Wisconsin Department of Transportation

Proposal #14: 2410-10-70, WISC 2026258
C Milwaukee, W National Ave,
39th St to 27th St
STH 59
Milwaukee County

This is Addendum No. 01, which provides for the following:

ADDENDUM NO. 01

Addendum No. 01
ID 2410-10-70
Revised Sheet 467
February 3, 2026

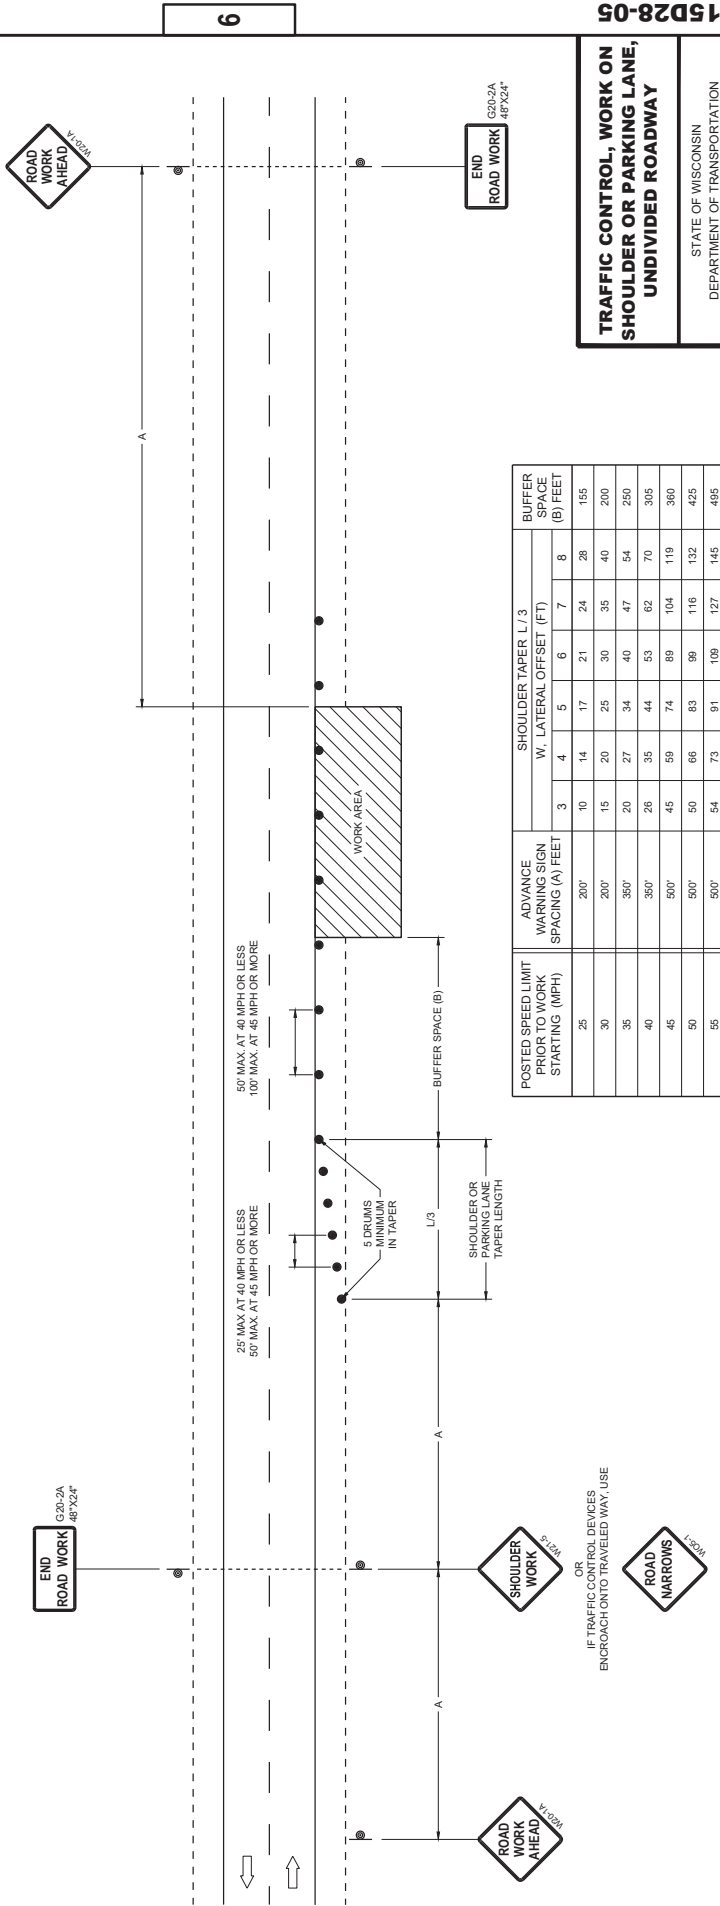
Revised Plan Sheets	
Plan Sheet	Plan Sheet Title (brief description of changes to sheet)
467	Miscellaneous Quantities (revised traffic control quantities to reflect addition of SDD 15D28-05 and to correct erroneous negative values)
